KARACHI MUNICIPALITY.

ORDER UNDER SECTION 96 (2) OF ACT. III OF 1901.

I have to inform you that the plan submitted by you for building making houses on plot No. 50 sheet No. N.P-5, Majra Quarter, is approved and permission to build in accordance therewith is granted. The building must be erected in accordance with the approved plans and deviations should not be made without previous sanction of the Municipality.

PLAN OF PROPOSED BUILDING
SHEET N. 50 SHEET N. P. 5.
PIPER QUARTER
SCALE 8:1 INCH

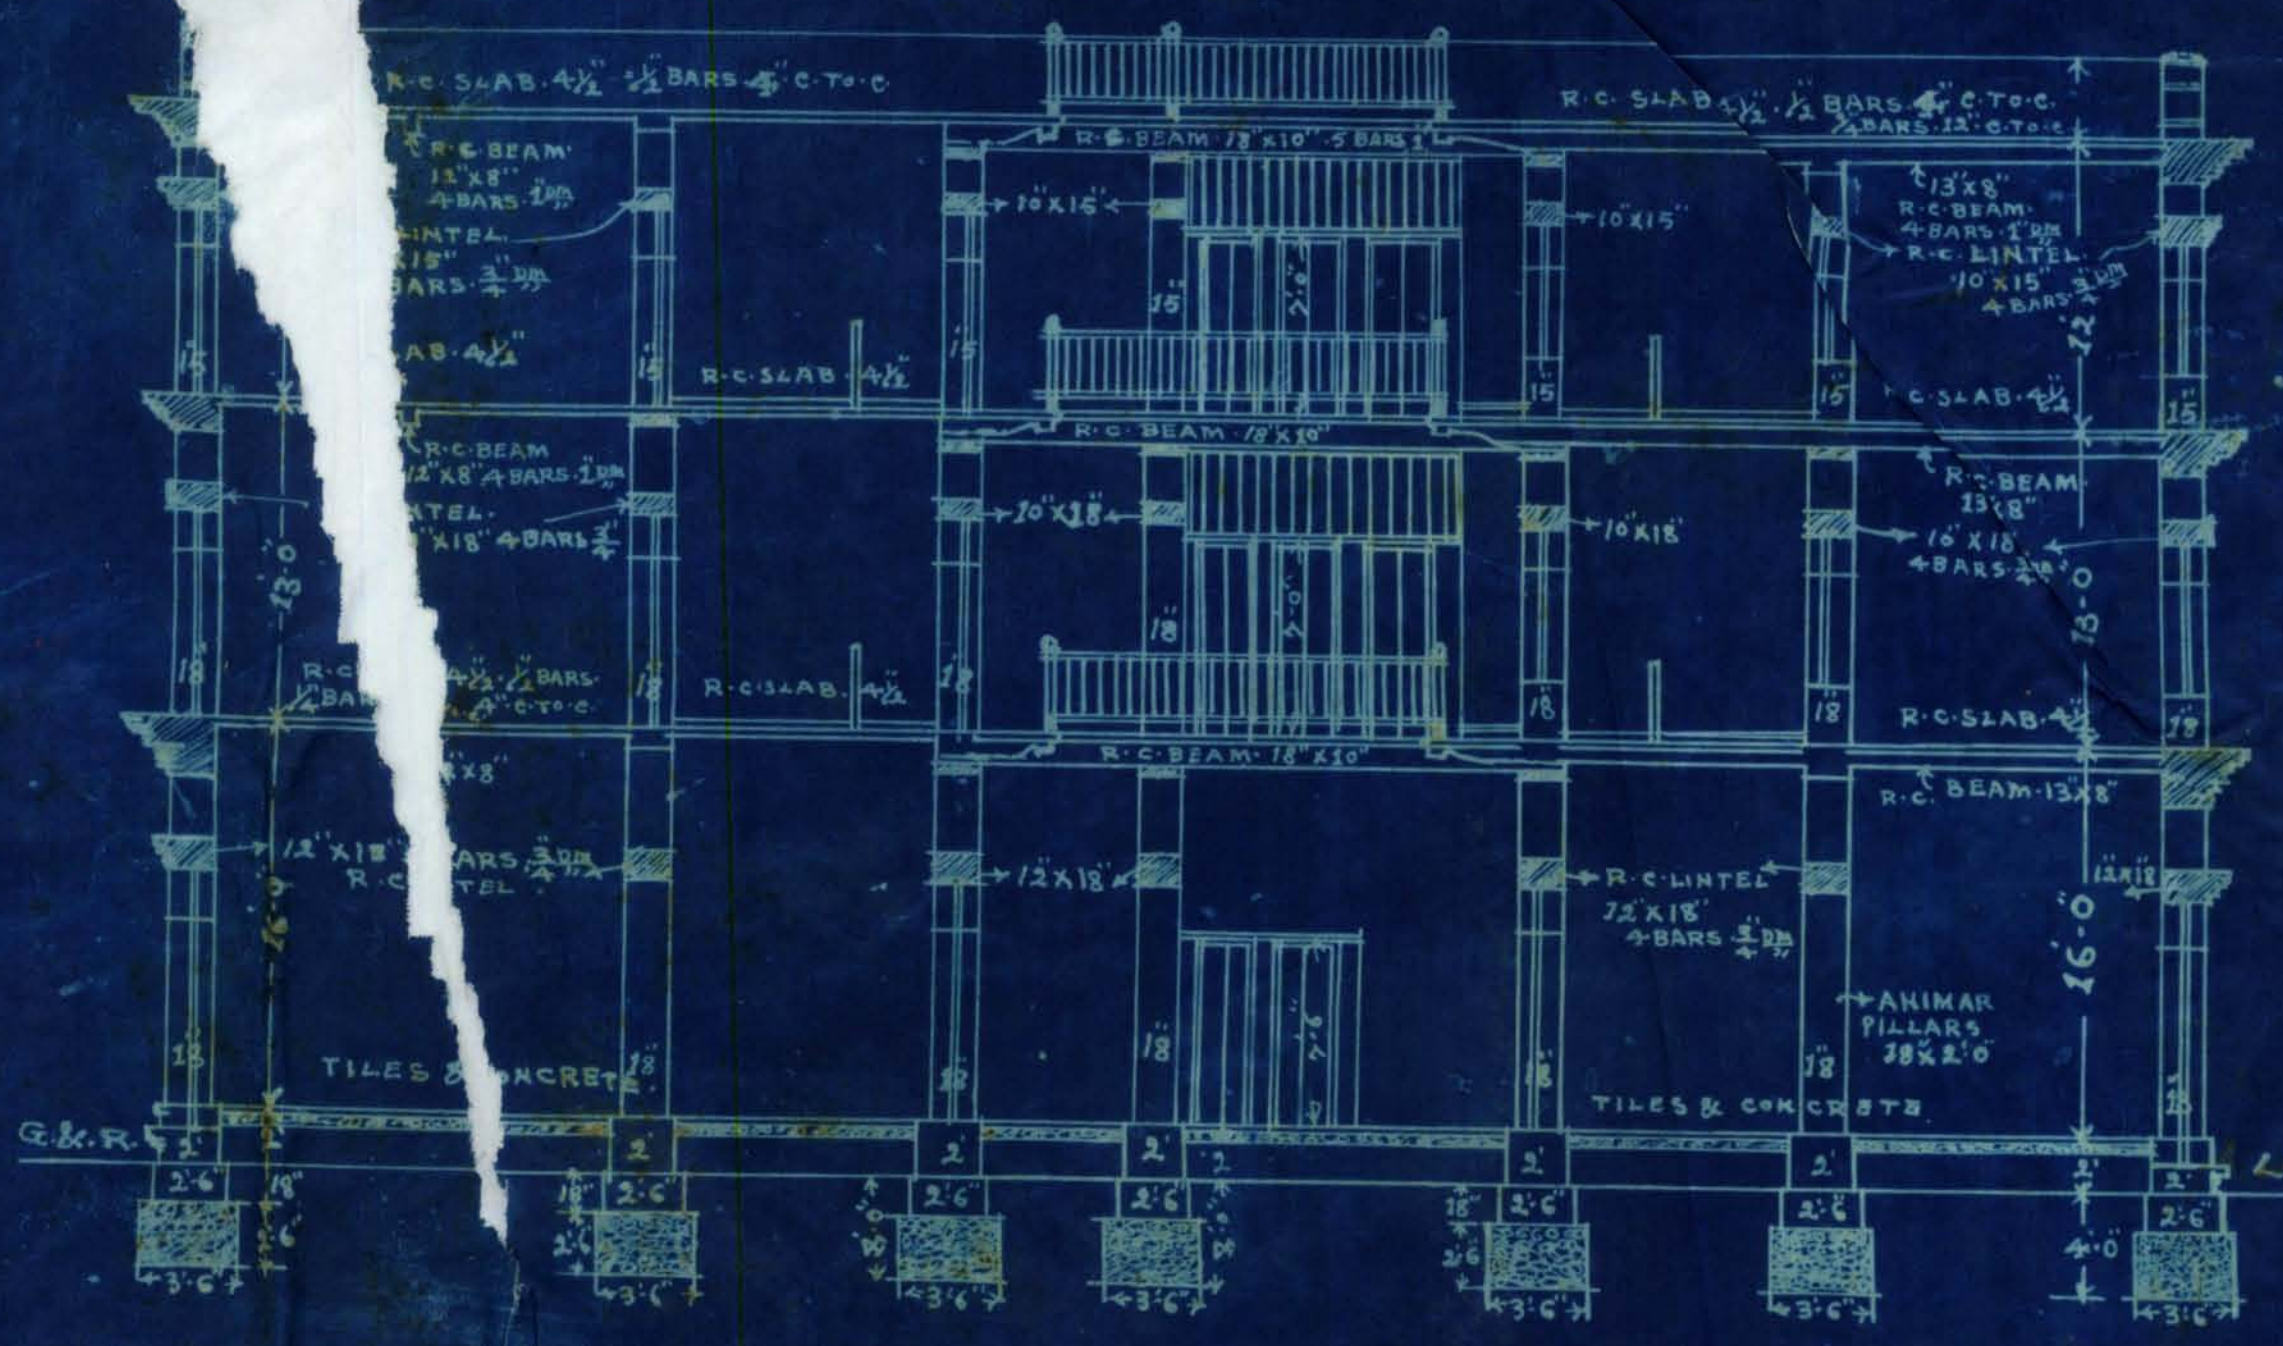
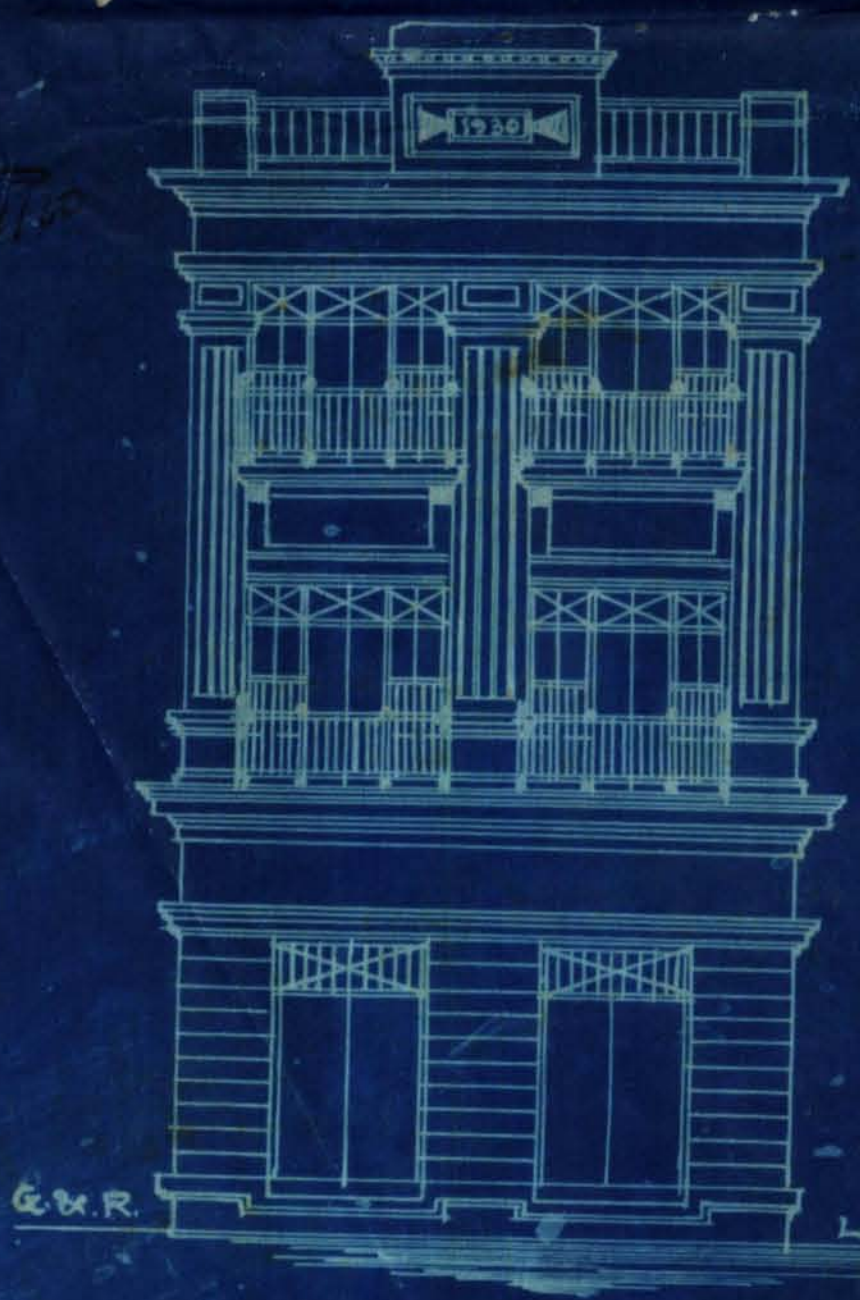
(1) central pillars should be of concrete.(2) 18"x10" A.C. beam should be increased to
20"x12" A.C. beams.(3) wall by the side of stair case to be of brick in plaster
material.

The beams must be provided to carry kitchen walls.
